Shivesh Singh - Scottish Hospital - Paddington Society submission

Scottish Hospital Redevelopment - MP10_0016 Part 3A
2 Cooper Street Paddington

BUILDINGS OVERWHELM HERITAGE & ALL STREETS

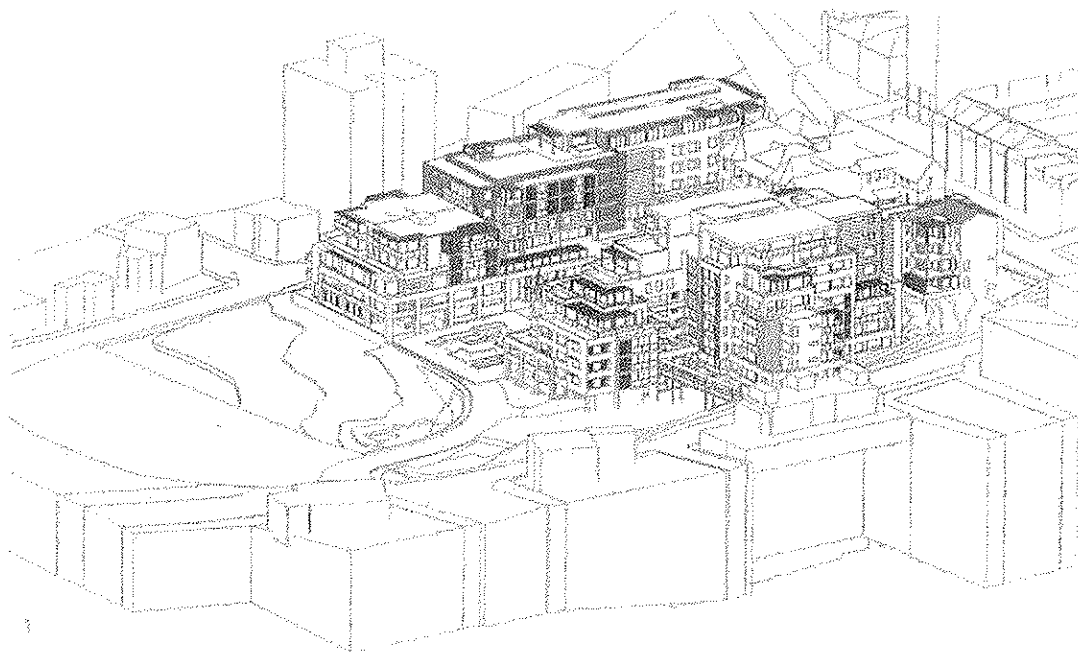
The Society supports the provision of Aged Care on the site of the Scottish Hospital, but opposes and objects to the current Part 3A proposal before the department. It is too big, too deep, too high and too intrusive.

The proposal destroys the heritage significance of the last intact Gentry Estate in Paddington.

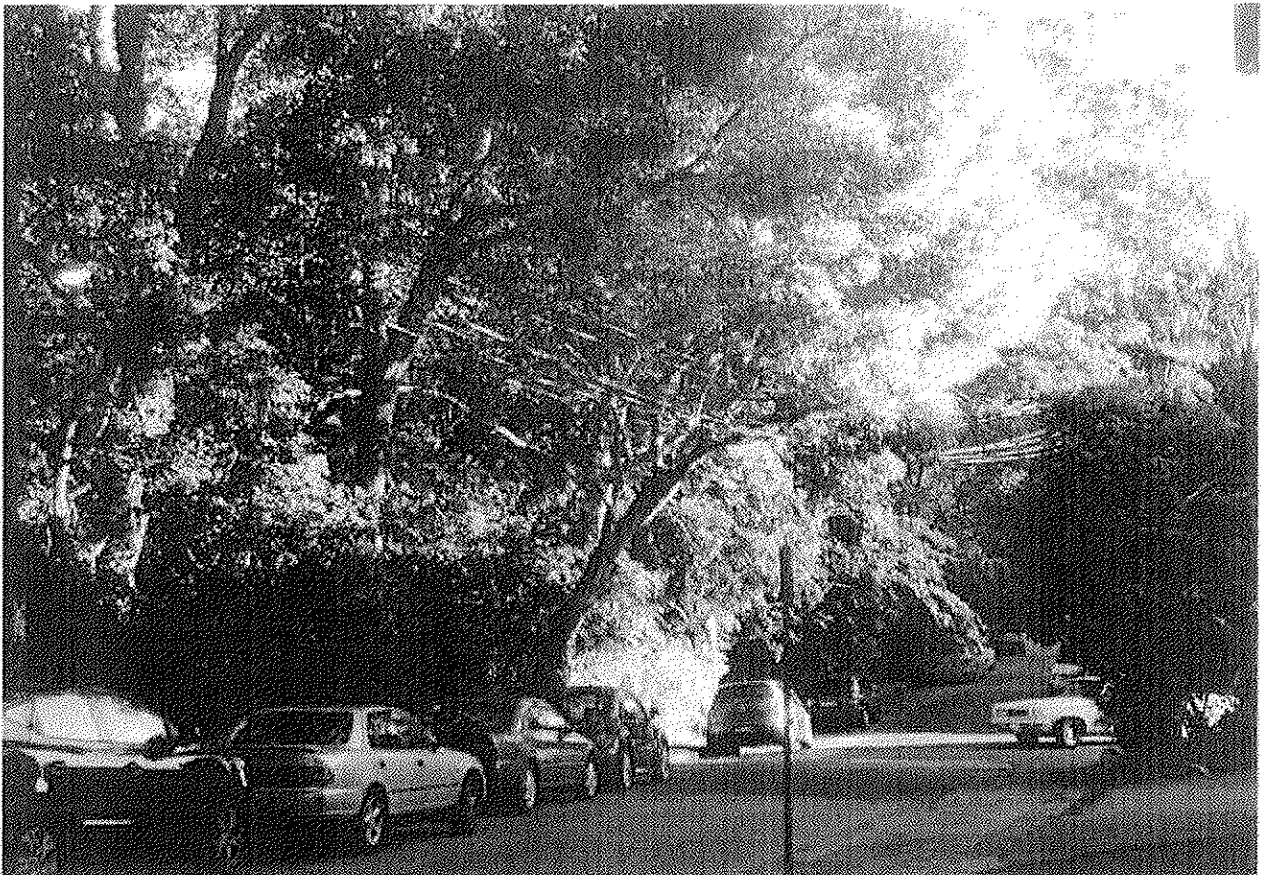
Excavation is perilously close to many trees proposed to be retained. Notwithstanding the "pruning analysis" for two of the trees T18 and T81 identified in the arborist report the basement excavation will require additional branch and root pruning for these and many other trees.

We also note that the dementia garden appears to be in the most important part of the original terraces and the upper terraces are "privatised" as private courtyards.

BUILDINGS OVERWHELM BROWN ST

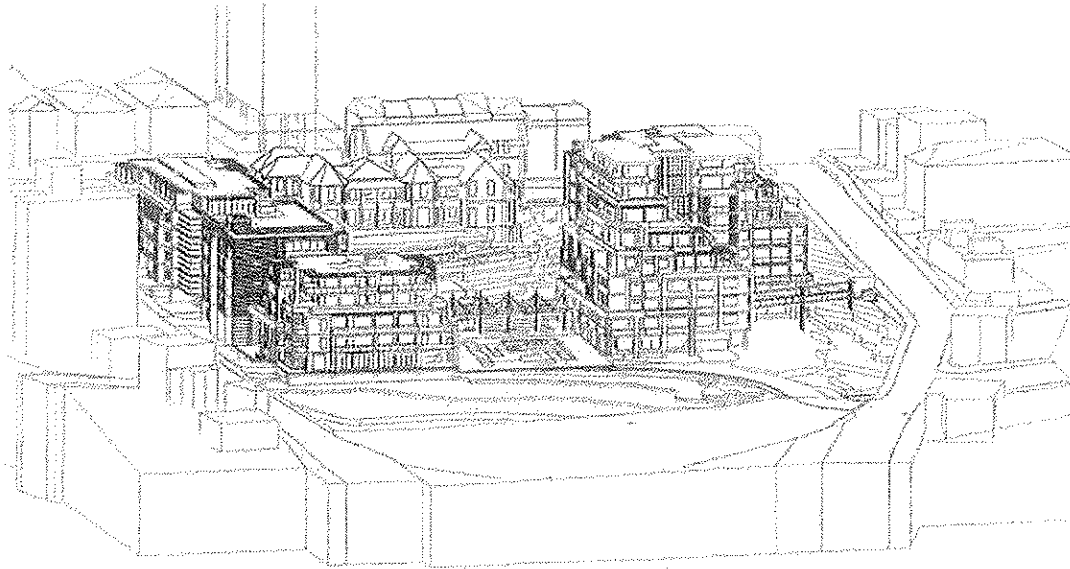
- The proposal does not comply with Seniors Living Policy-Urban Design Guidelines for infill development 2004 with regard to context, respect for heritage, built edges and impact on neighbours.
- The proposal does not comply with SEPP 65 or the RFDC with regard to scale, built form, density, landscape, amenity, affordability or aesthetics.
- The proposal does not comply in fact or spirit with the Woollahra LEP 1995.
- The proposal does not comply with the Paddington Heritage DCP.
- The proposal does not comply with Woollahra Council's Planning Principles for the site.
- The Paddington Society does not support the applicant's urban design study.
- The Brown Street ILU is too high at 9 floors near Brown Street and too close to Brown Street.

BUILDINGS OVERWHELM · STEPHEN ST.
HERITAGE

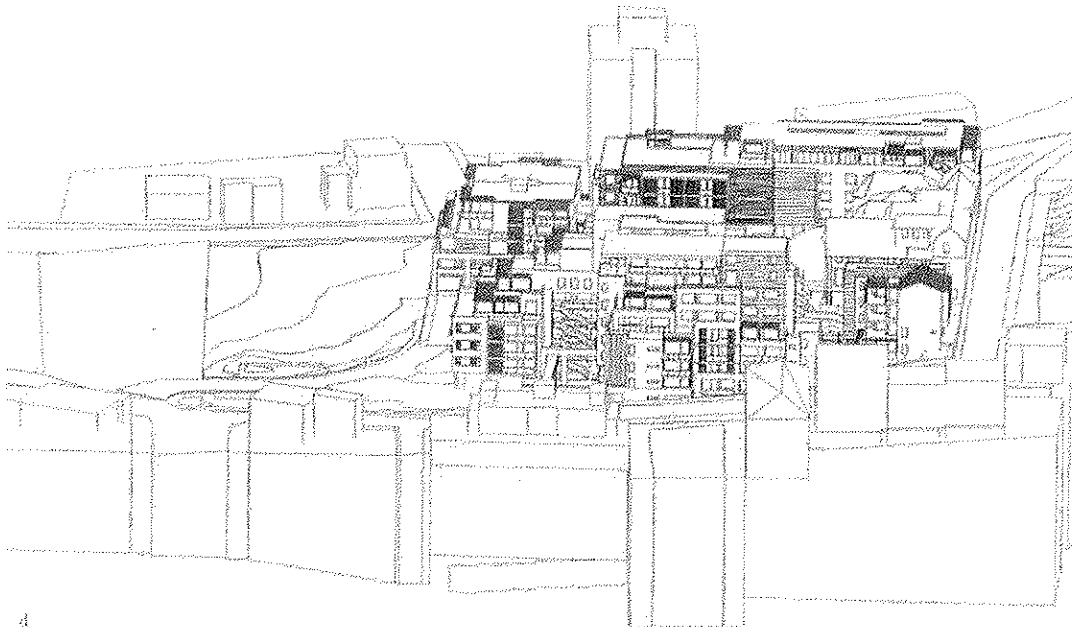
- The Stephen Street ILU is too high and too close to Stephen Street.

- The Stephen Street ILU intrudes into the Glen Street view corridor and should be deleted.
- The new buildings dominate the terraces.
- The architectural response is too fractured and too stepped in form, trying to mitigate unsuccessfully against its height and bulk.
- No construction should be permitted in the Brown Street gully
- The Conservation Management Plan fails to properly consider the heritage significance of the gardens and grounds. No landscape conservation management plan is provided.
- The Paddington Society opposes the demolition of the terraces.
- No heritage assessment of the trees has been provided.
- Consequently the urban design analysis carries no weight.

BUILDINGS OVERWHELM • GLENVIEW ST.
• GLEN ST.

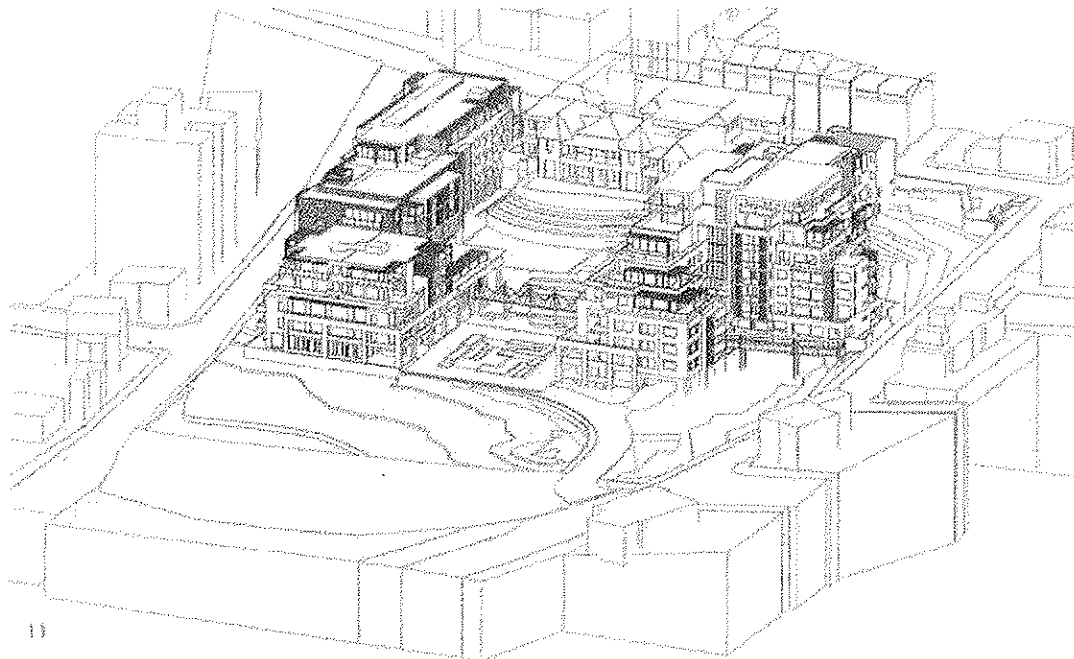
- The heritage impact on the house and grounds is unacceptable.
- There is no support from the local community for the proposal's impact on the public domain.
- The proposal will deprive 38 Stephen Street of solar access from 1.30pm.
- No trees should be removed simply because they are within "construction zones"
- No Retention Value A or B trees should be removed
- The view impact on Brown Street, Glenview Street, Dillon Reserve, Stephen Street and Glen Street is unacceptable.
